ADDENDUM NO. 1

Issue Date:	March 12, 2026
School / Facility Name:	Spirit Elementary
Project Name:	Upgrade HVAC Bldg. 7
Owner's Project No.:	2648250

Owner:	School Board of Volusia County Florida 200 N. Clara Avenue, DeLand Florida 32720
Owner's Project Manager:	Mike Semon
Project Manager's Location:	3750 Olson Drive, Daytona Beach Florida 32124

ED101

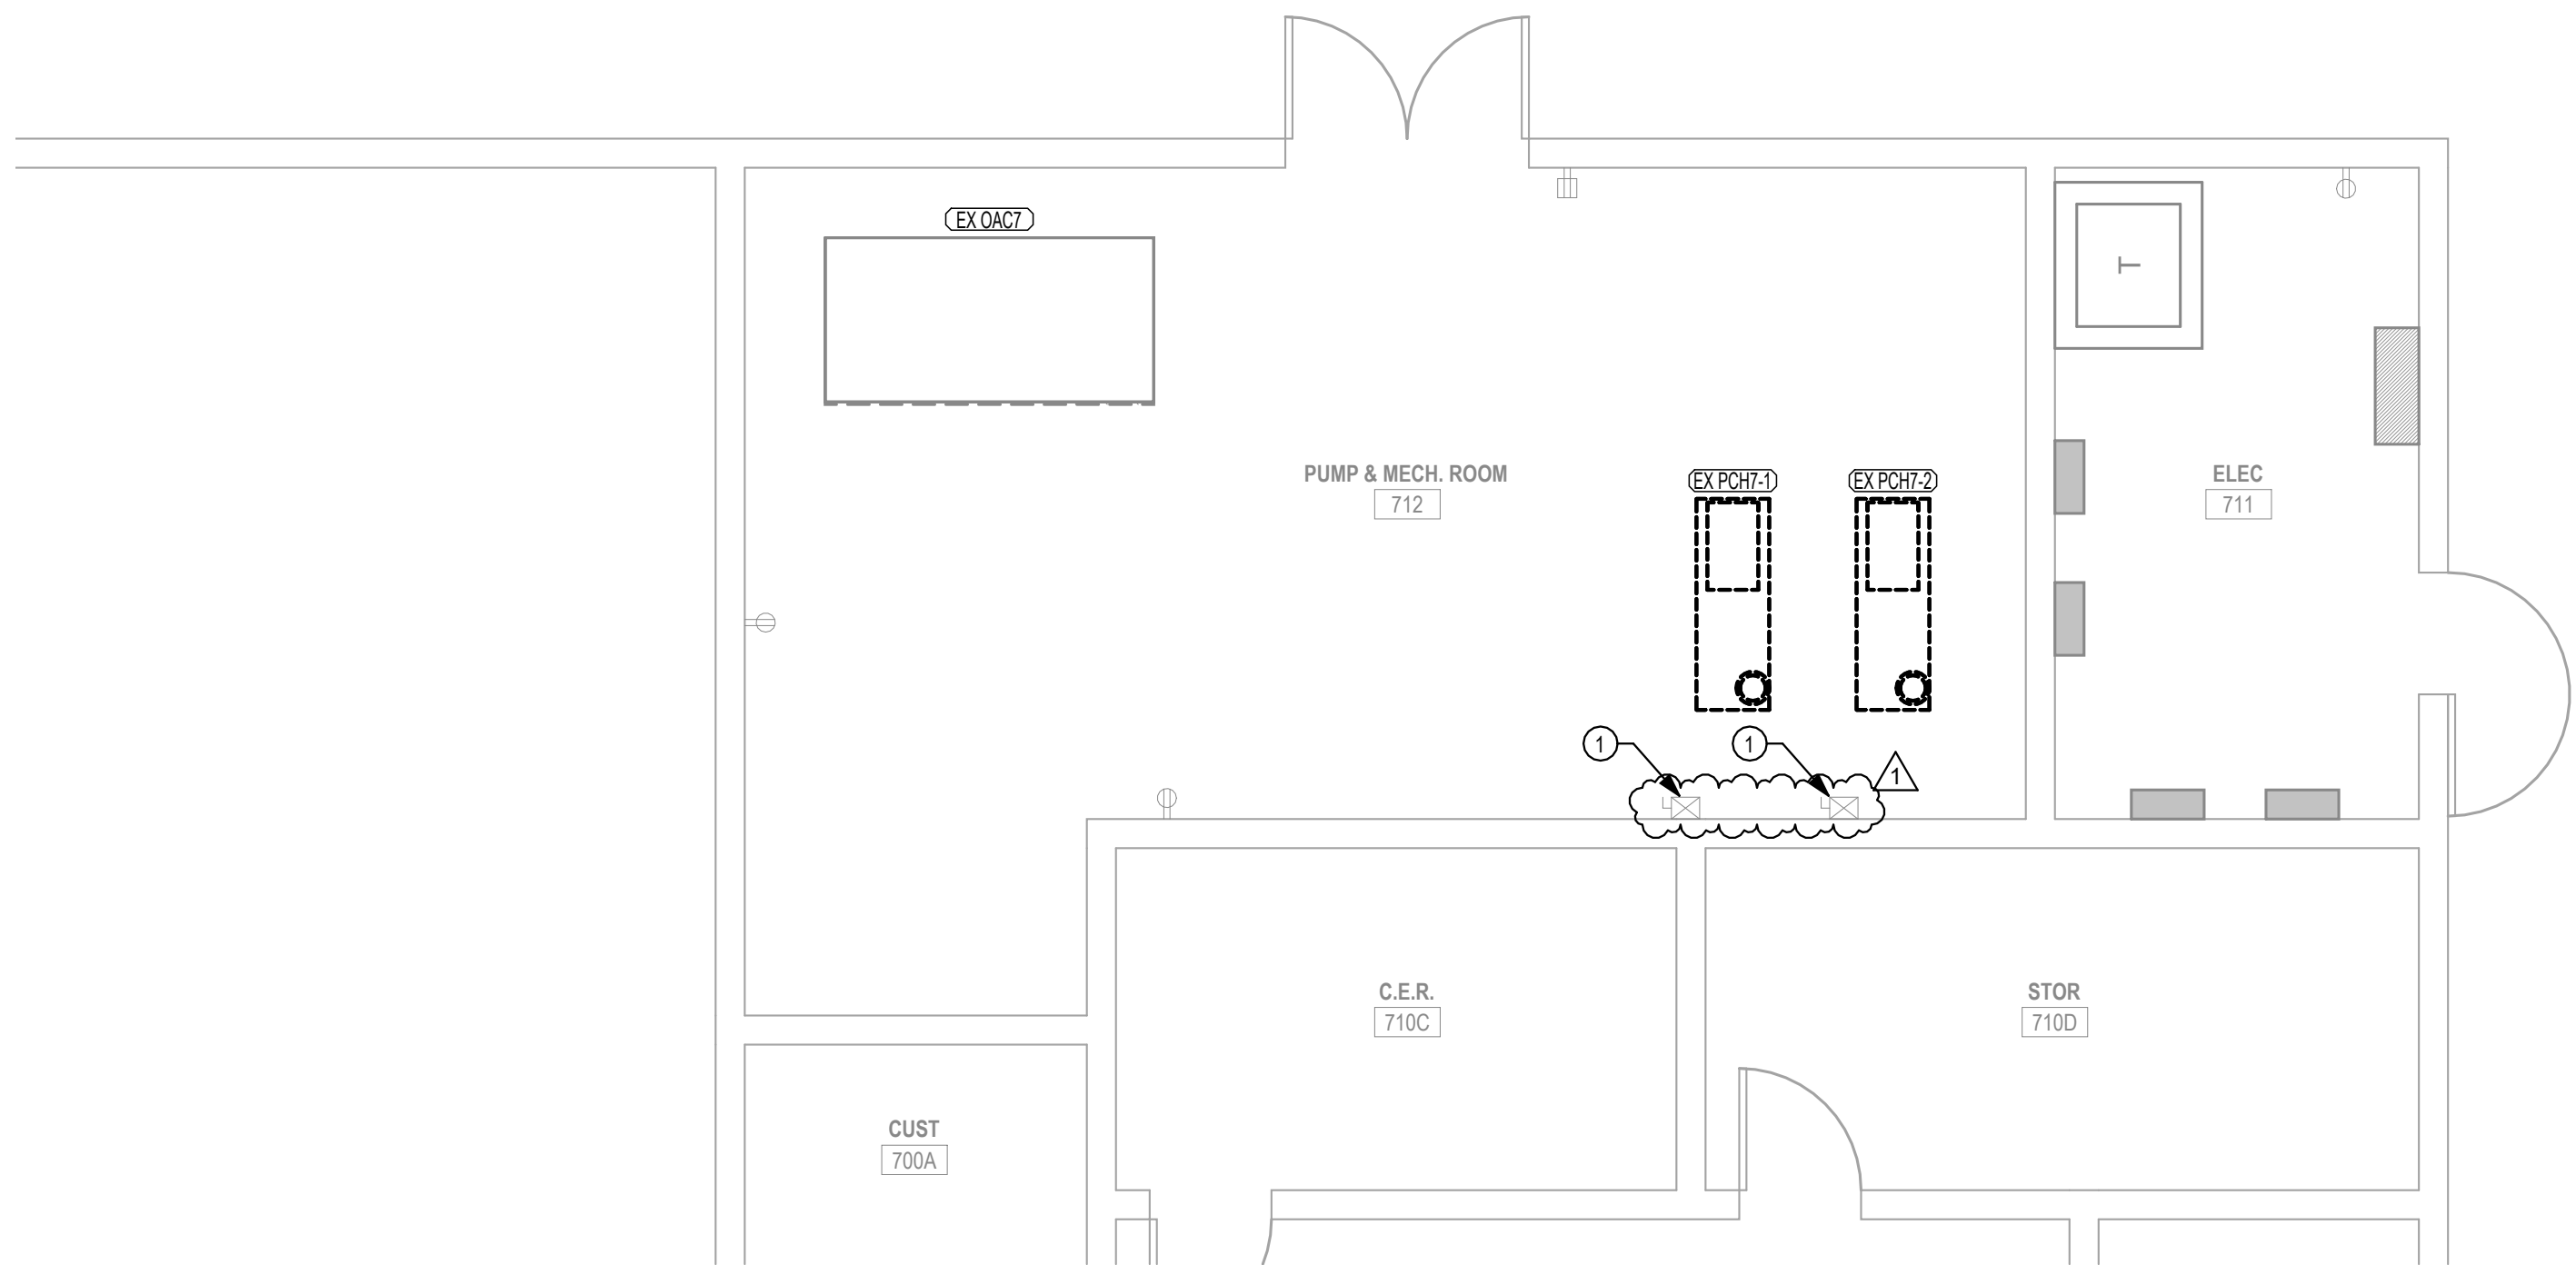
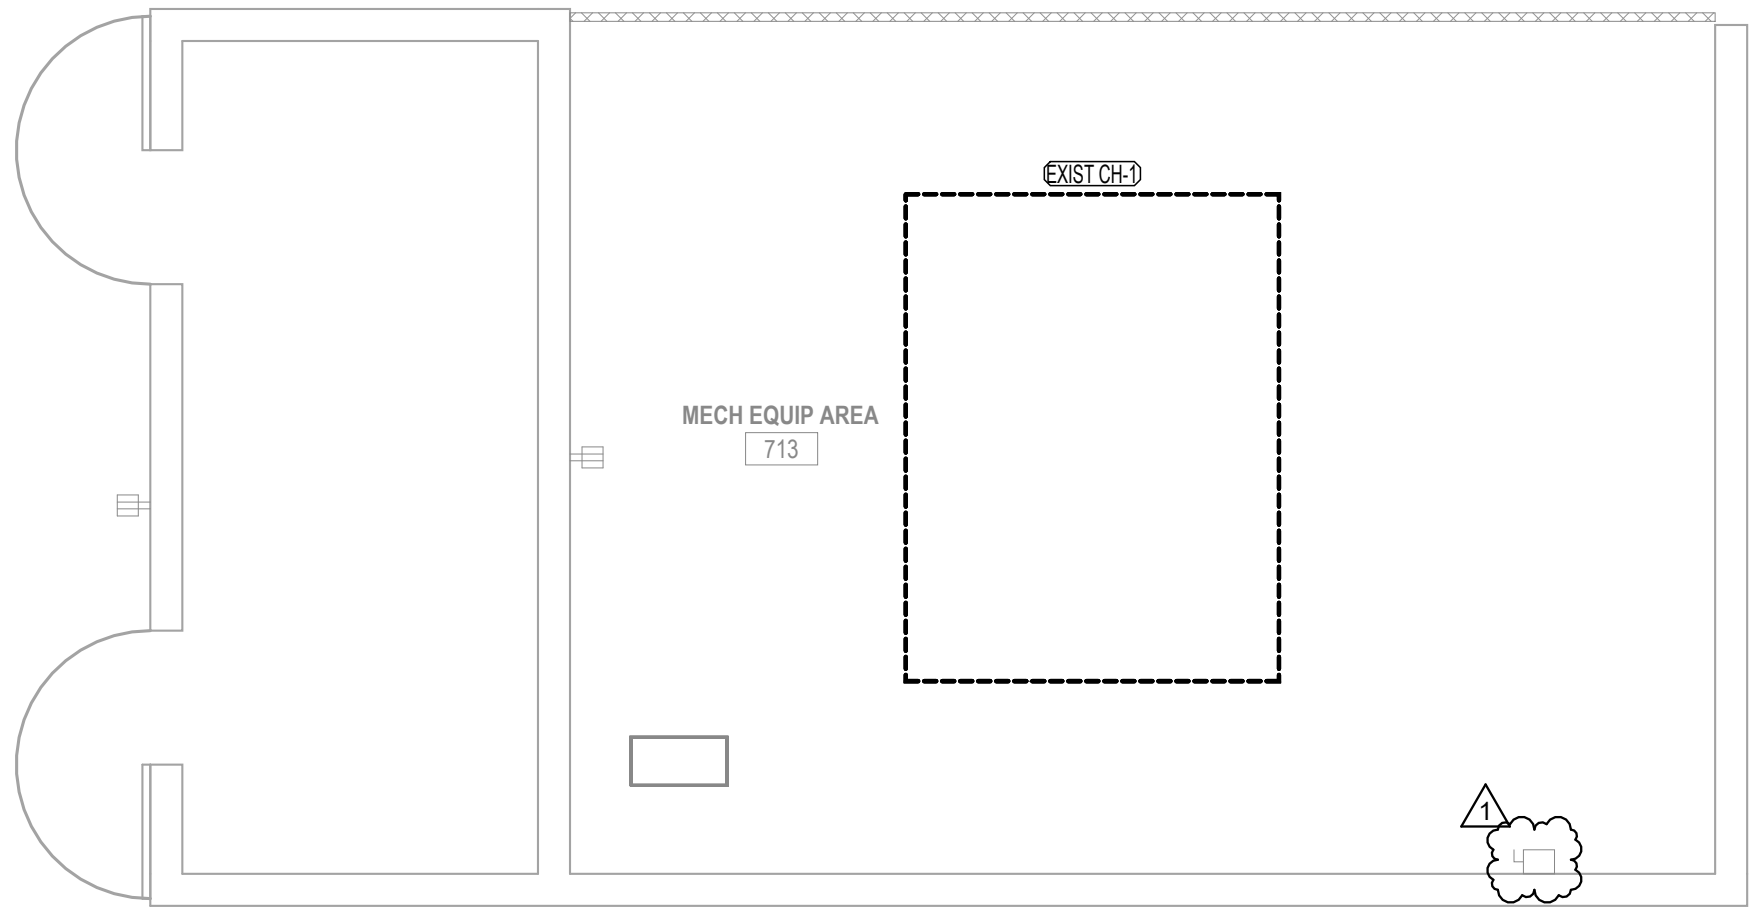
ED101 Electrical Demo Plan:

Plans revised to show existing disconnects as existing to remain.

E101

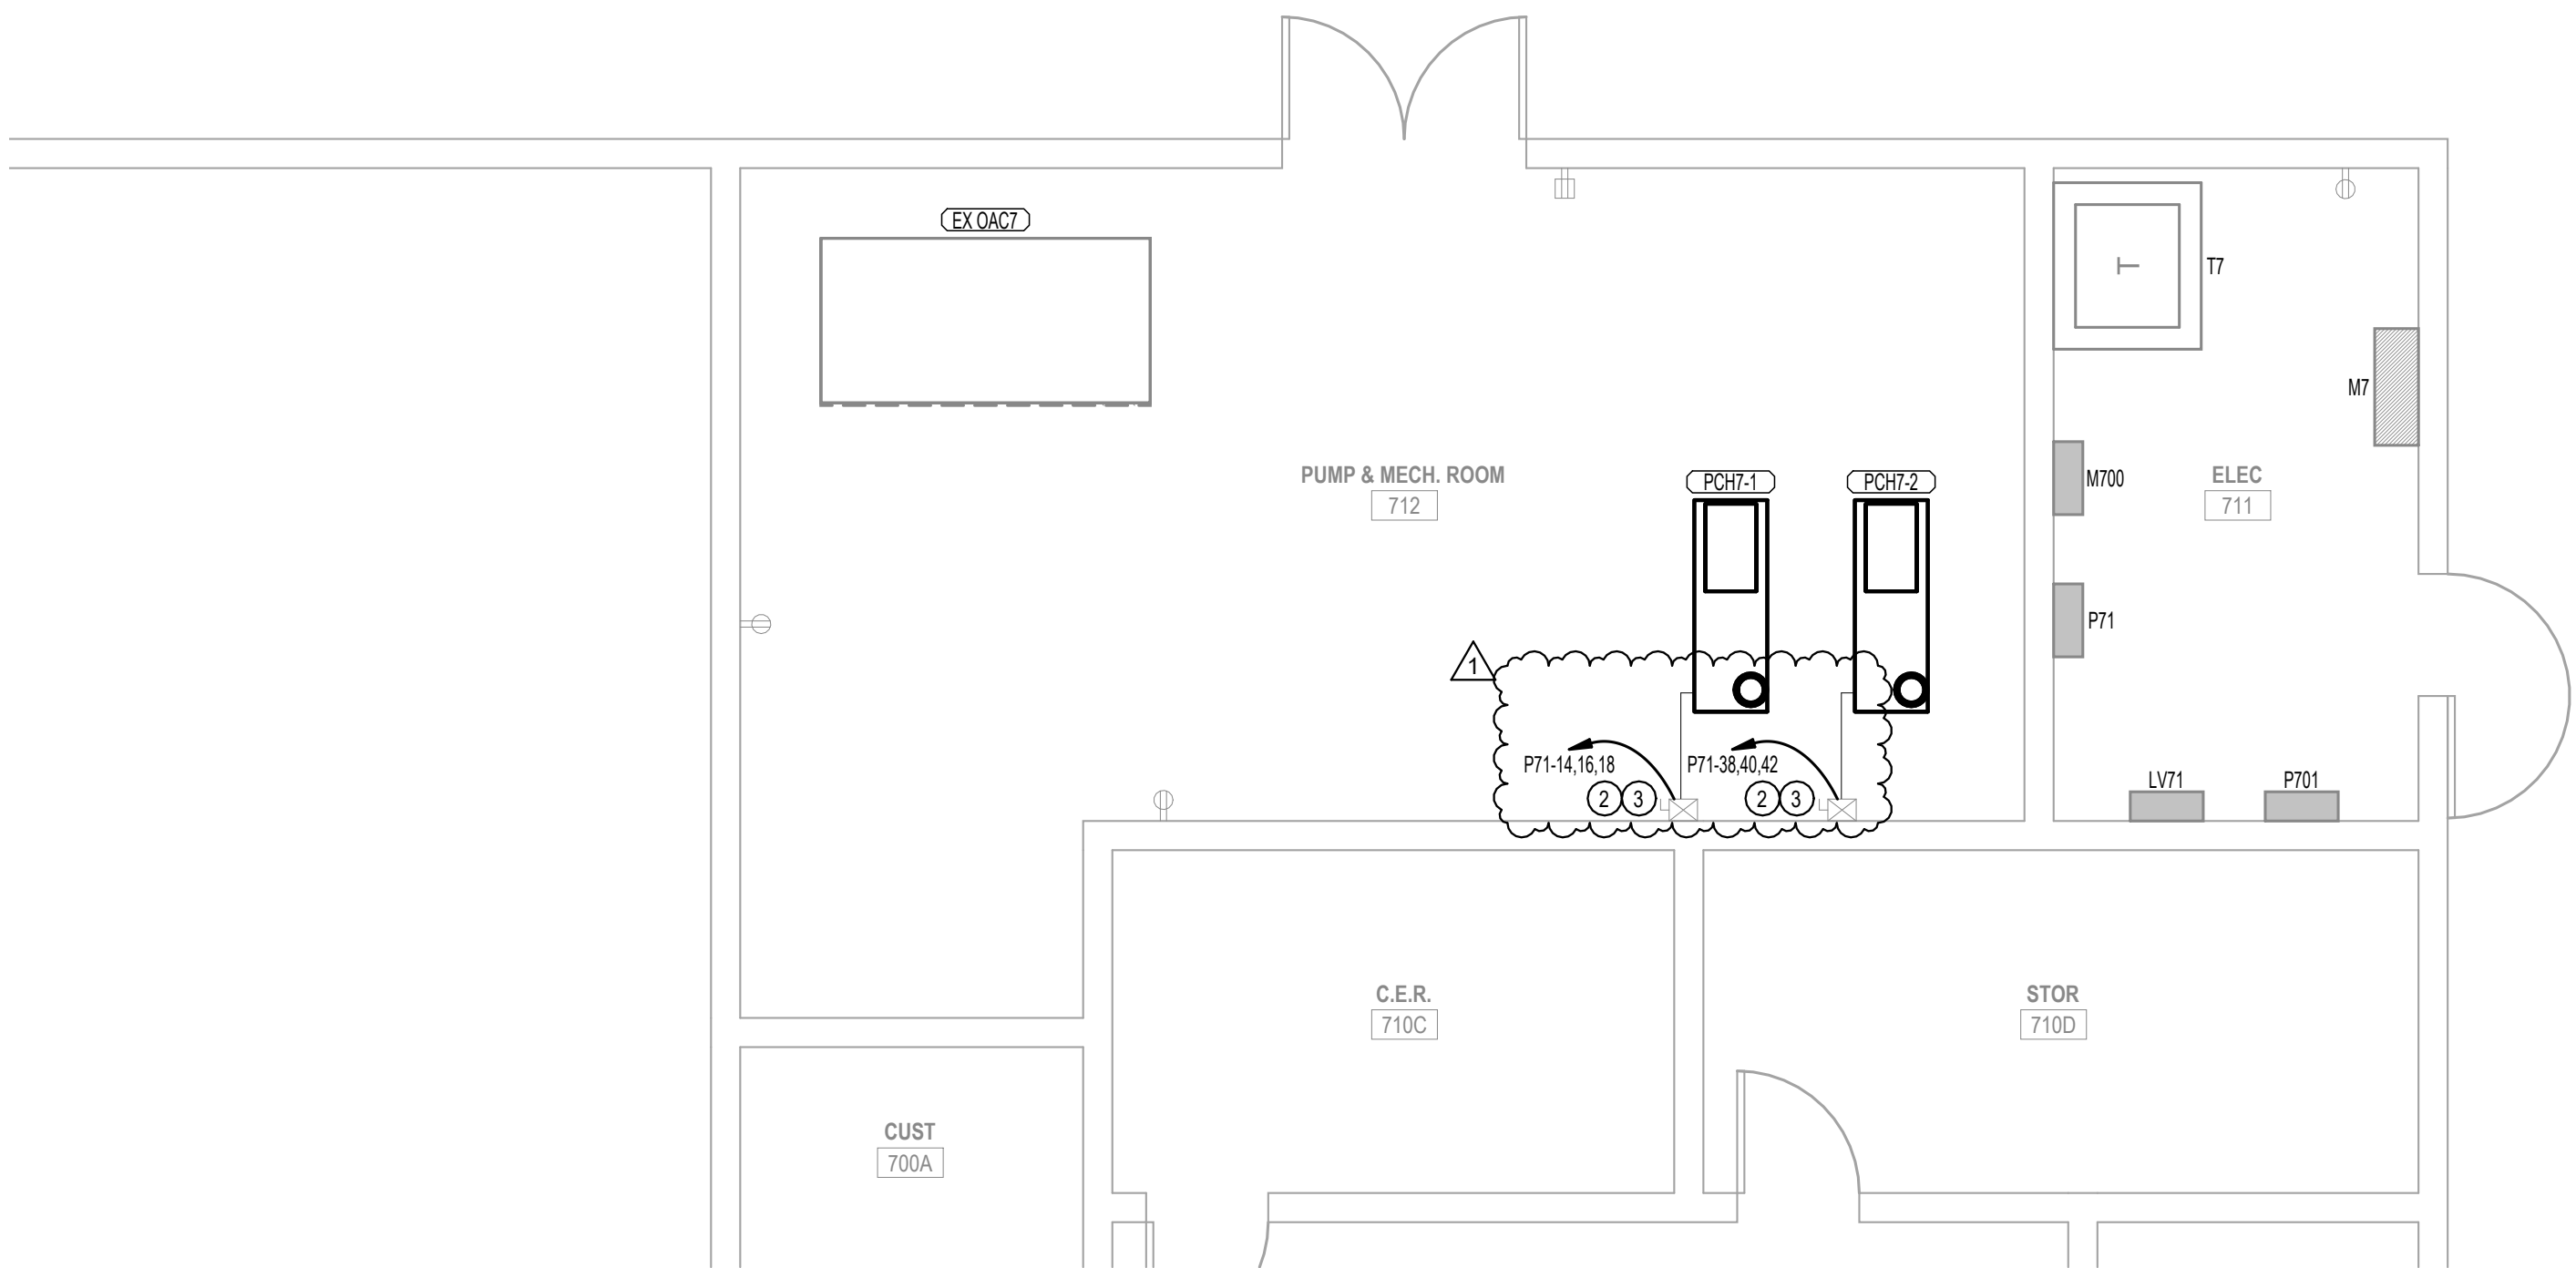
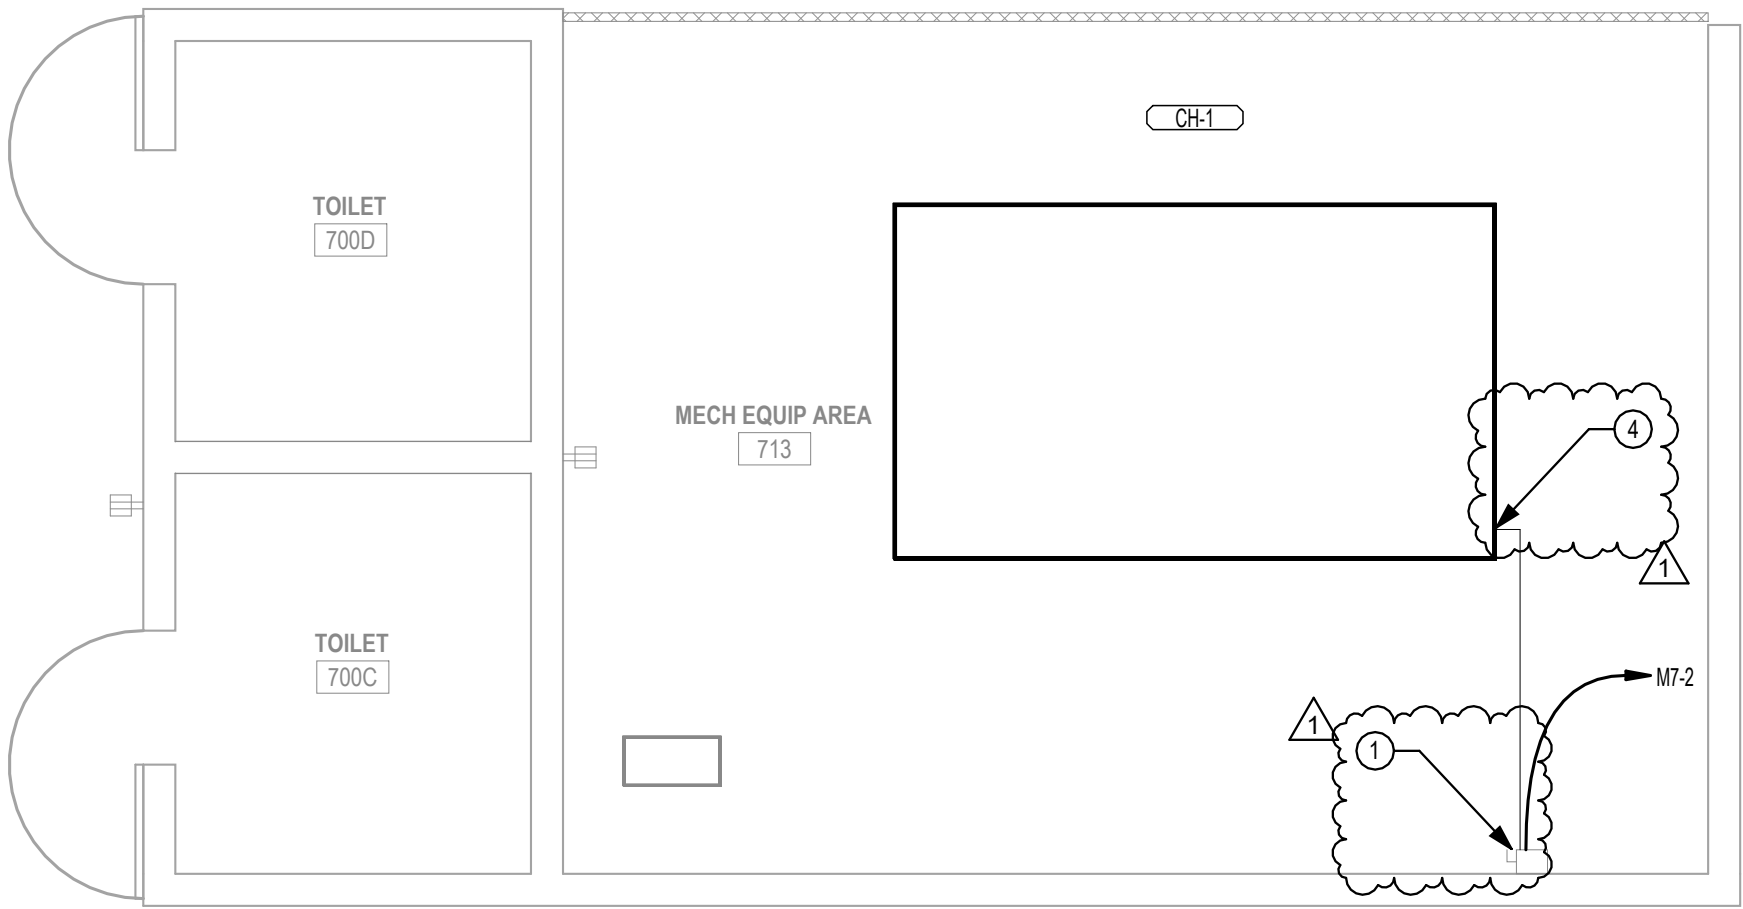
QUESTION 1: Where is the power connection point located on the new chiller? Will it be the same as the existing chiller?

RESPONSE: The chiller and pump disconnect switches may be reused. The drawings have been revised to show this. The conductors and conduit between the pumps and the electrical panel will need to be replaced as they no longer share a circuit.

E101 Electrical Plan:

Sheet revised to show power connection location on chiller and information regarding the replacement of existing conduit and conductors for the pumps.

RESPONSE: The connection point is located on the plan Southeast of the Chiller. Approximate location is shown on the plans.
